RAIL COACH FACTORY, KAPURTHALA

Sub: Coach Alteration Instructions for modifications to be carried out in LHB EOG AC 2T and 3T Coaches for segregation of 110V DC +VE and –VE at all levels and provision of Cage Clamp Terminals with Glass Fuses for enhanced Fire Safety.

CAI N O.: ED/CAI/033 Dated: 02.04.2024

COACH ALTERATION INSTRUCTION SHEET FOR SEGREGATION OF 110V DC (+VE & –VE) AT ALL LEVELS, AND PROVISION OF CAGE CLAMP TERMINALS WITH GLASS FUSES FOR ENHANCED FIRE SAFETY IN LHB EOG AC 2T & 3T COACHES

a) Modifications in Under frame Area:-

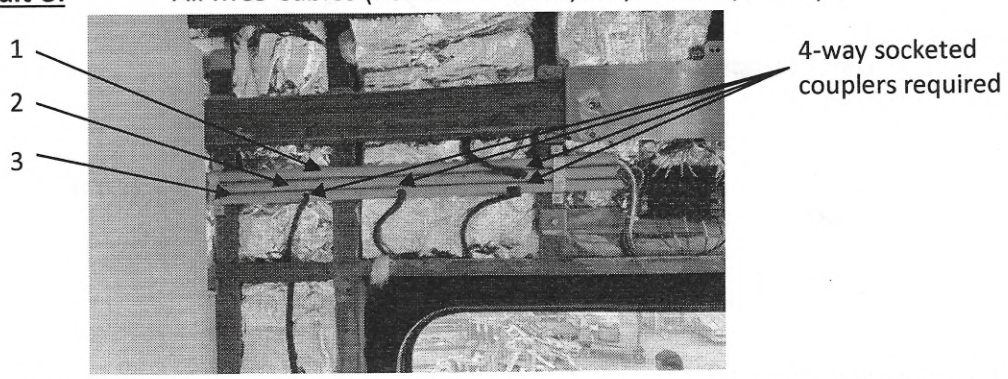
1. Segregation of 110V DC +VE & -VE Cables is already being done in existing LHB Coaches as the output cables from 4.5 KW RBC i.e. 110V DC +VE, +VE & -VE are routed to SBC, Battery Fuse Box (+VE) and Battery Fuse Box (-VE) respectively via. different polyamide conduits, hence no change is required in under-frame wiring.

b) Modification in Side Wall Area :-

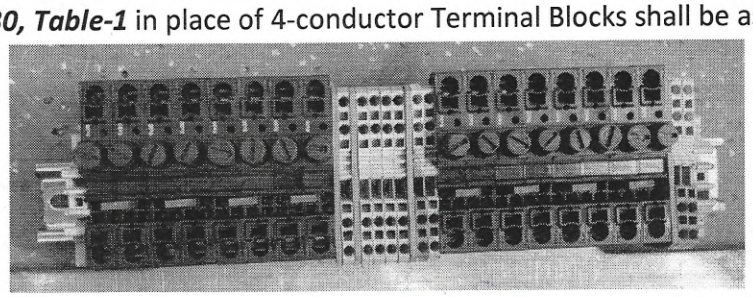
1. 01 no. additional hole of dia. 04 mm shall be made from the existing bottom side hole at C-C 88 mm for provision of the triple conduit clamp to Drawing No. ***LP76001, Alt-'c', Item-16.***
2. 01 no. additional PVC Rigid Conduit shall be laid above the existing 02 nos. PVC Rigid Conduits on the sidewall for Jumper wiring and clamping of the same shall be done with the help of triple conduit clamp as shown below. Wiring shall be routed from SBC to Cage clamp terminals via. these 03 nos. PVC Rigid Conduits as per following details:-

Conduit -1: All DC -VE & Earthing Cables (i.e. 110V DC FLD-, FLS-, NL-, ALARM-, PE (Light))

Conduit -2: All DC +VE Cables (i.e. 110V DC FLD+, FLS+, NL+, ALARM-I+, ALARM-II+ (Loop))

Conduit-3: All MCS Cables (i.e. 110V AC Ph., Ph., Neutral, Earth).

Cage Clamp Terminals with connections (Cabin-5)

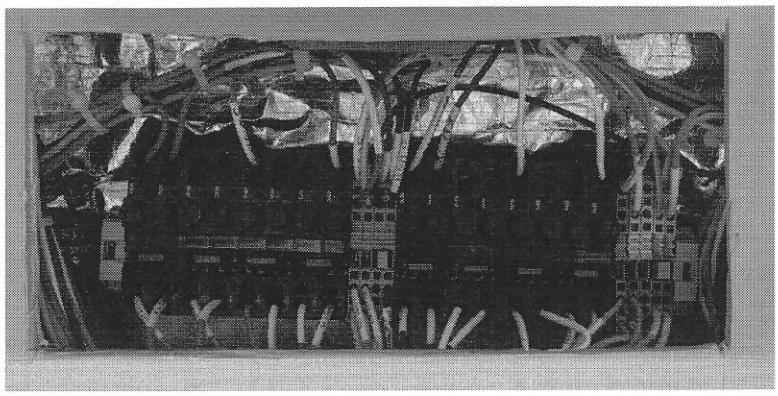
3. Due to increase in size of Cage Clamp Terminals provided, the length of PVC Conduit for Jumper wiring shall be reduced by 250 mm (approx). i.e. from 1700 mm to 1450 mm (08 Nos.) & 1000 mm to 800 mm (02 Nos.).
4. 4-Way socketed couplers on the PVC conduits as per Drawing no. ***SKED-947*** shall be provided in each cabin area for passing of MCS and DC +VE wiring at locations for cables exit to switches.
5. Provision of Cage Clamp Terminals with Glass Fuses similar to LHB Non AC Coaches as per ***EDML-230, Table-1*** in place of 4-conductor Terminal Blocks shall be as follows :-

6. Din Rail of length 300 mm shall be mounted at 15 mm below the existing terminal strip mounting location for accessibility on the same WAGO Bracket. Accordingly, connections shall be done.

Length of Din Rail = 300 mm

Length of WAGO = 270 mm

c) Modifications in Roof Area:

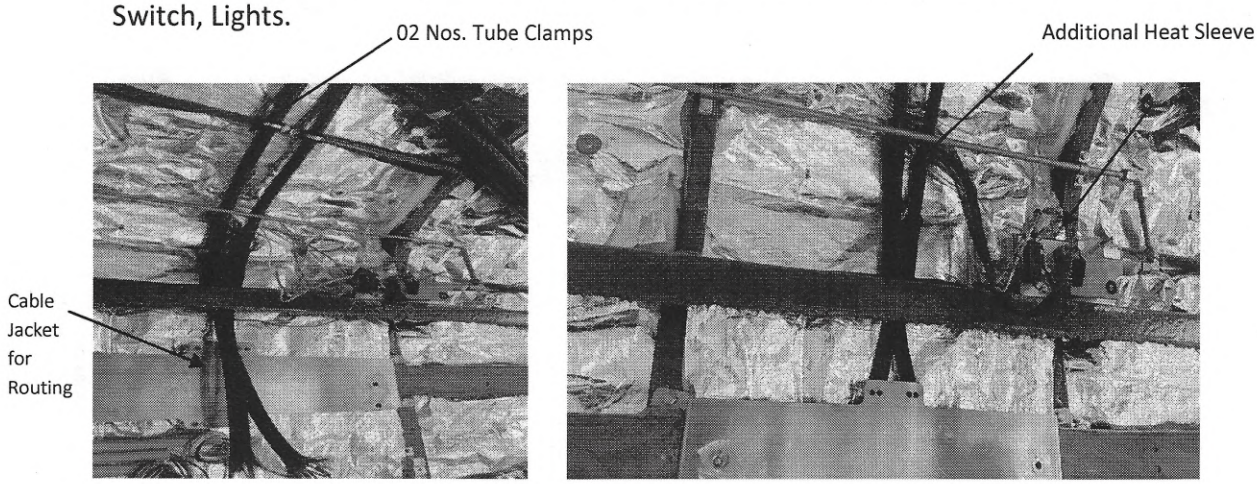
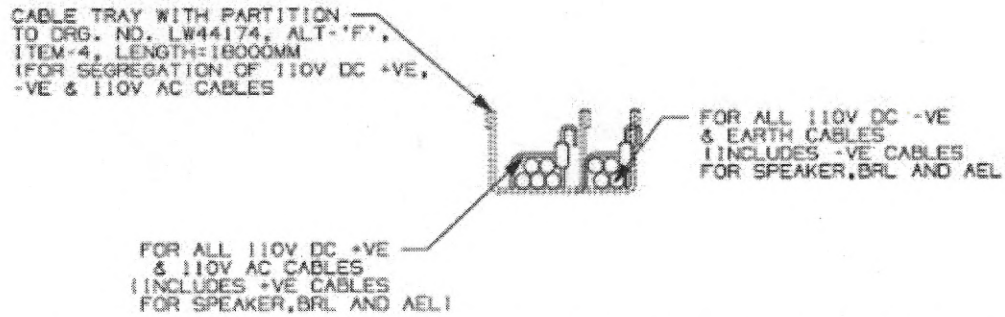
1. Segregation of 110V DC +VE & -VE shall be done in Branch Wiring by providing extra NW-12 flexible conduit, however due to only 01 No. Cable drop hole in Cant-rail for passing of NW-12 Conduit, branch wiring shall be done with Cable Jackets from the hole to Terminal Strip for easy routing of cables through 01 no. hole. These two Conduits shall be clamped with 02 nos. Tube clamps at the roof. Additional sleeve shall be used for routing of cables separately from conduit to equipment i.e. Limit Switch, Lights.

2. The existing cable tray arrangement to Drawing No. LW44174, Item-6, Length = 18000 mm shall be replaced with Drawing No. LW44174, **Item-4,** Length = 18000mm with provision of partition between Cable tray for segregation of DC +VE & -VE, AC cables in Roof.

3. The segregation of 110V DC +VE & -VE wiring shall be done for Speaker Circuit, AEL Circuit with AC Circuit Cables and 110V DC +VE Cables on one side and 110V DC –VE and Earth Cables on other side with the help of partition in Cable Tray being provided in the Corridor Area.

DETAIL AT-S

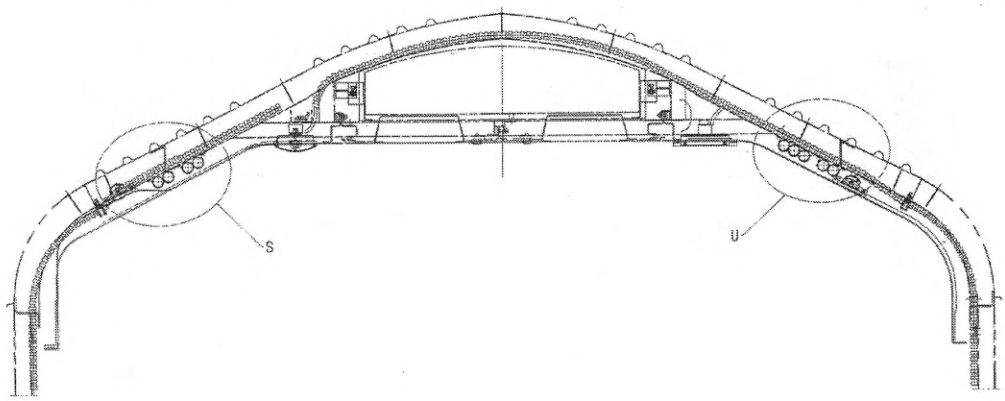
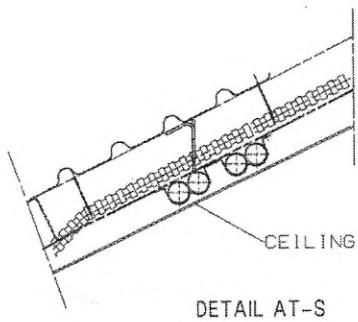
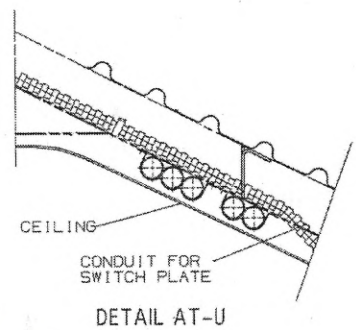
4. Lavatory wiring from PP end to NPP end shall also contemplated in dia. 40 mm PVC Rigid Conduits. The cables as provided in conduits dia. 40 mm in Roof is as under:

- 02 conduits for RMPU wiring
- One no. conduits with all DC +VE cables
- One no. conduits with all DC -VE cables
- One no. conduit with AC cables (including pantry wiring)

Details for 04 Nos. Conduits:-
02 Nos. for RMPU Cables
01 No. for UIC Cable
01 No. for Temperature Sensor Cables

Details for 05 Nos. Conduits:-
02 Nos. for RMPU Cables
01 No. for Pantry Equipments Cable (3-Ø, 415V AC + 3Ø, 110V AC (if req.))
01 No. for Lav. Wiring (110V DC +VE)
01 No. for Lav. Wiring (110V DC –VE)

d) Modifications in FRP Panels :

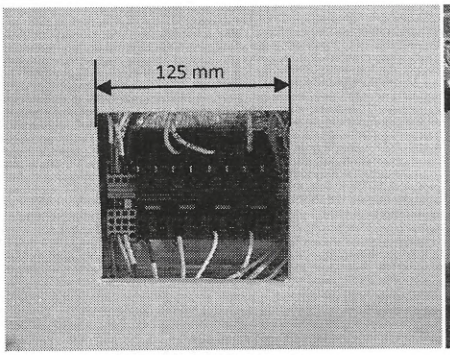
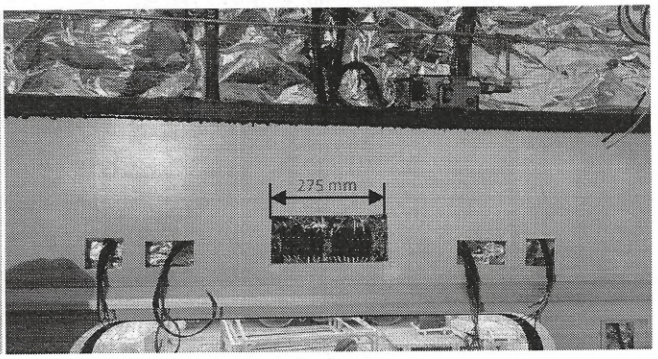
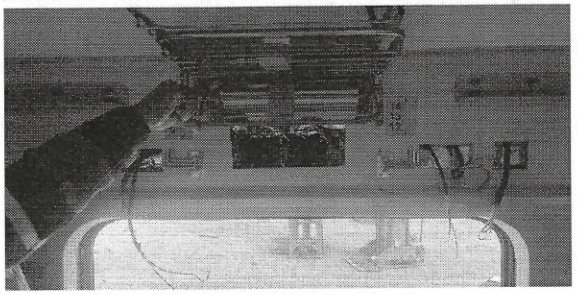
1. As the length of the Cage Clamp Terminals is 270 mm approximately, the cut-out on the FRP panel behind mirror shall be modified to 275 mm (lengthwise) in-place of existing 125 mm to accommodate the Cage Clamp Terminals keeping the center at the same of the cutout at the same location. The FRP Panel shall be fixed on the sidewall and Mirror along with Luggage rake with no infringement shall occur.

Existing Cut out

Extended cutout

Behind Mirror View

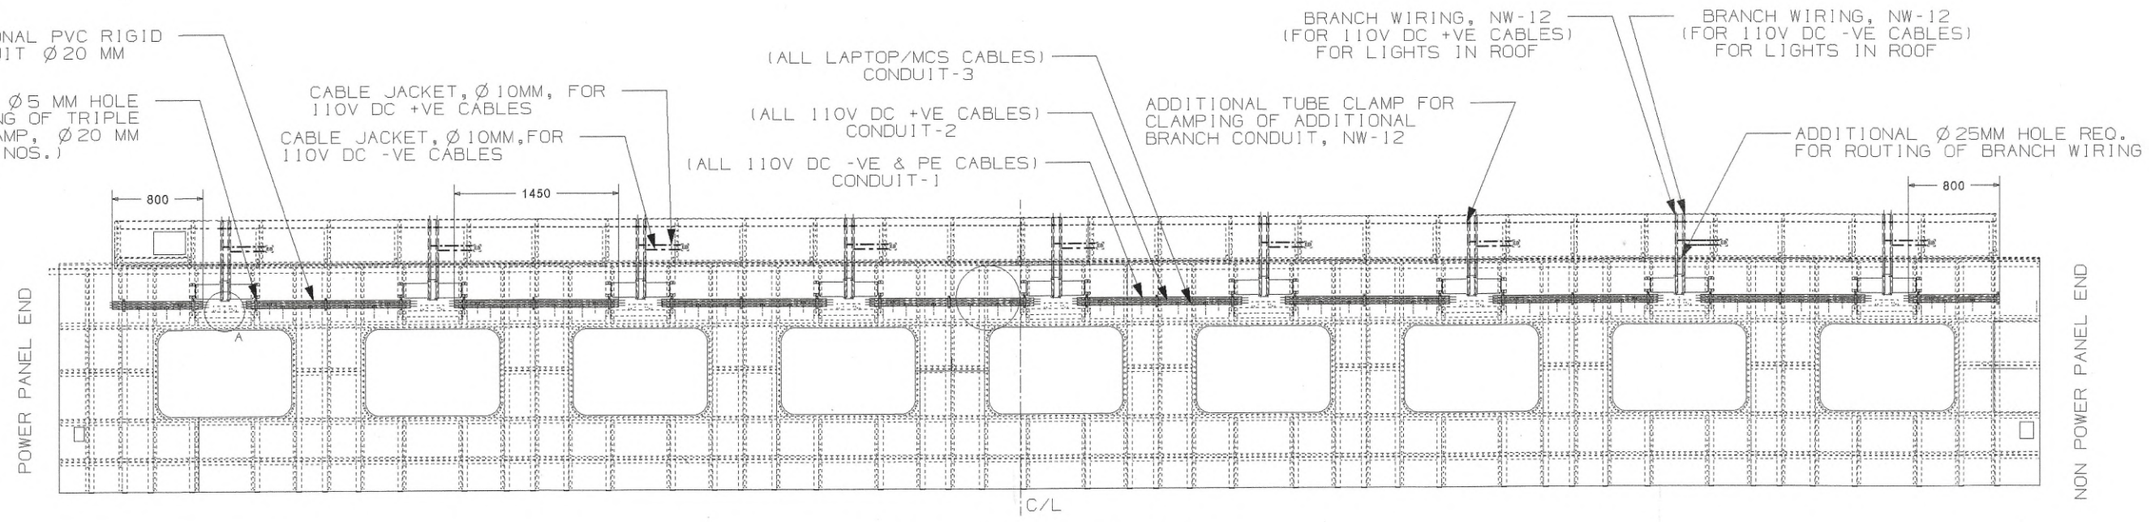
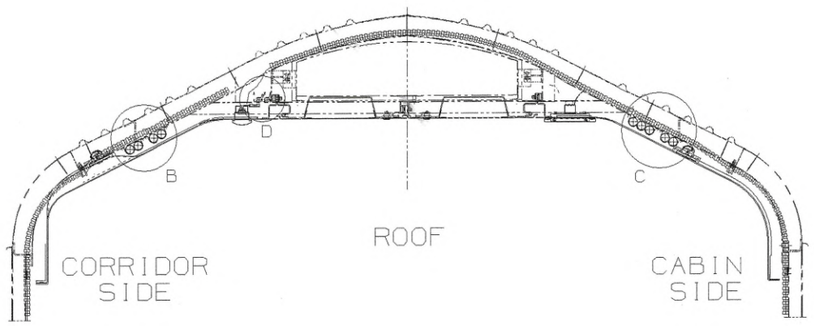
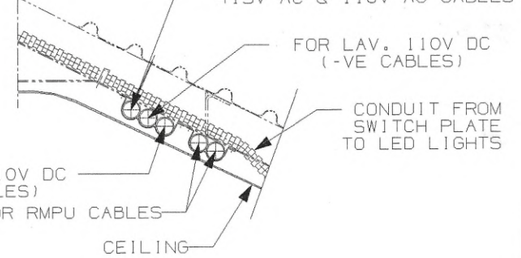
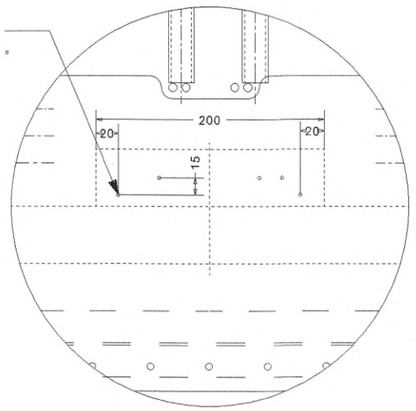
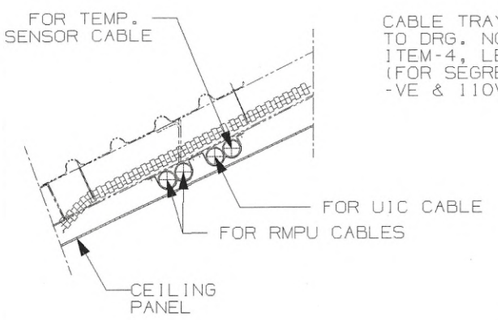
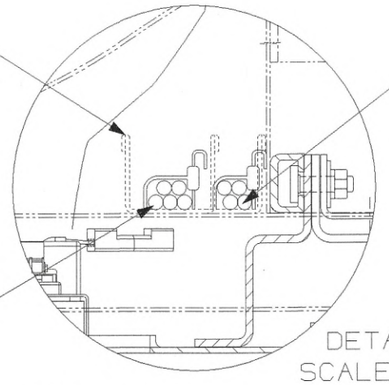
4. CUT-OUT IN FRP PANEL BEHIND MIRROR TO DRG. NO. LE44215, ALT-'J' SHALL BE INCREASED FROM 125MM(L)X125MM(W) TO 275MM(L)X125MM(W) FOR ACCOMODATING CAGE CLAMP TERMINALS.
3. REFERENCE CONNECTION DIAGRAM SHALL BE AS PER SKED-938.
2. CAGE CLAMP TERMINALS WITH GLASS FUSES SHALL BE PROVIDED AS PER SKED-938.
